# Intel® StrongARM®\* SA-1110 Microprocessor

Specification Update

*April 2001*

Order Number: 278259-022

**Figure 9-2. Interrupt Controller Block Diagram**

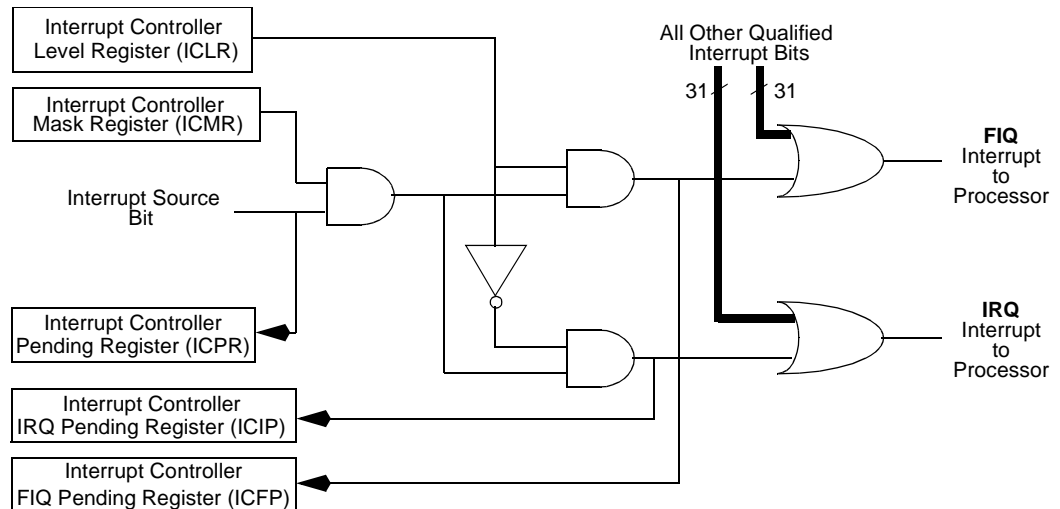
Made the following changes to Figure 9-2.

- Changed Interrupt Level Register to Interrupt Controller Level Register (ICLR)
- Changed Interrupt Mask Register to Interrupt Controller Mask Register (ICMR)
- Changed Interrupt Pending Register to Interrupt Controller Pending Register (ICPR)
- Changed IRQ Interrupt Pending Register to Interrupt Controller IRQ Pending Register (ICIP)
- Changed FIQ Interrupt Pending Register to Interrupt Controller FIQ Pending Register (ICFP)

Figure 9-2 now appears as:

## 51. DMA Device Address Register (DDARn): Section 11.6.1.1

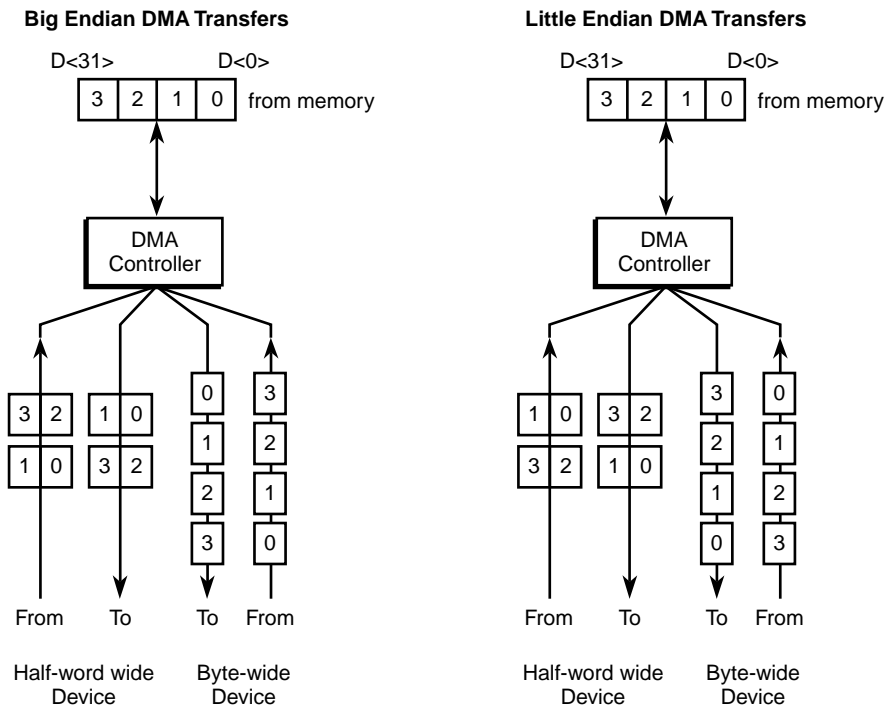
Corrected Figure 11-2.

Figure 11-10. Passive Mode Beginning-of-Frame Timing

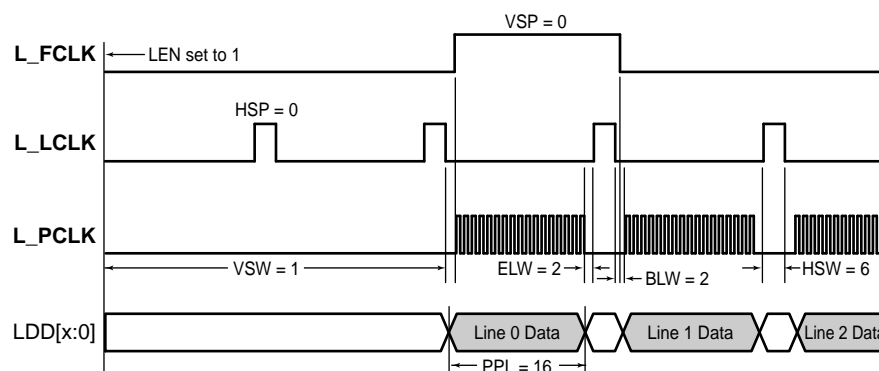
Changed the Notes: in Figure 11-10 to show the range of HSW as 1 to 64, not 0 to 64. The corrected figure is shown below:

Figure 11-11. Passive Mode End of Frame Timing

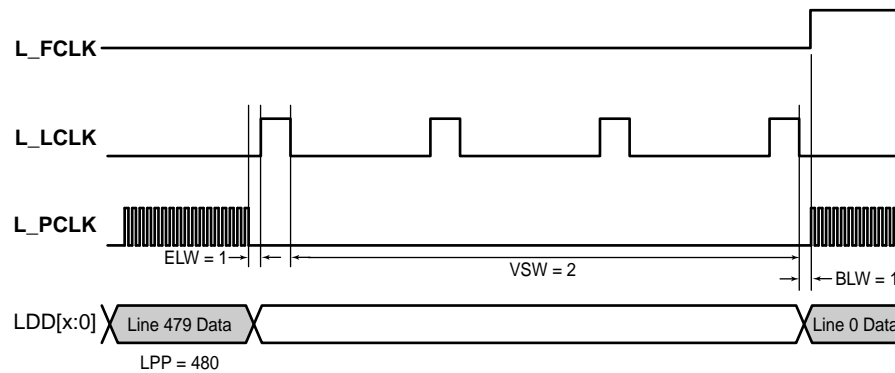
In Figure 11-11 at the location where L\_LCLK is deasserted just prior to Line 0 Data, there are two vertical bars depicting BLW = 1. Extended the right vertical bar upward to near L\_LFCLK. At this point, changed L\_FCLK to show a transition from deasserted to asserted (shown below.)

Also, changed the Notes: in Figure 11-11 to show the range of BLW as 1 to 256, not 0 to 256. The corrected figure is shown below:

Figure 11-13. Active Mode Timing

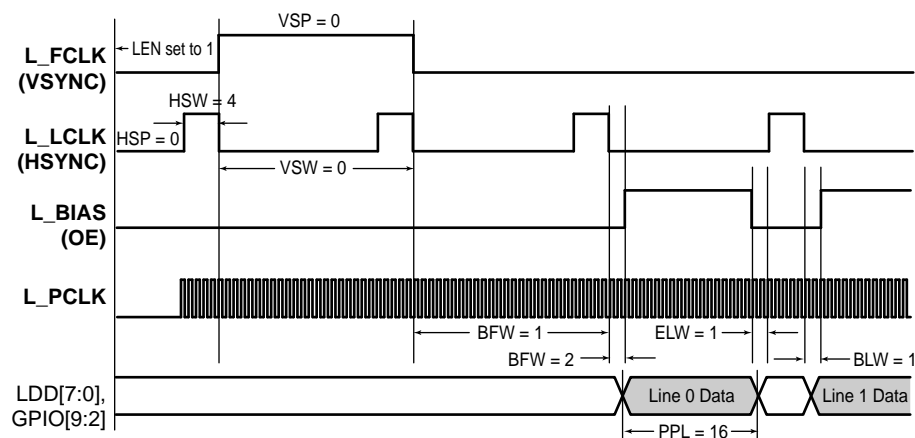
Corrected Notes: in Figure 11-13 to show the range of PPL as 16 to 1024 (not 1 to 1024.) The corrected figure is shown below:
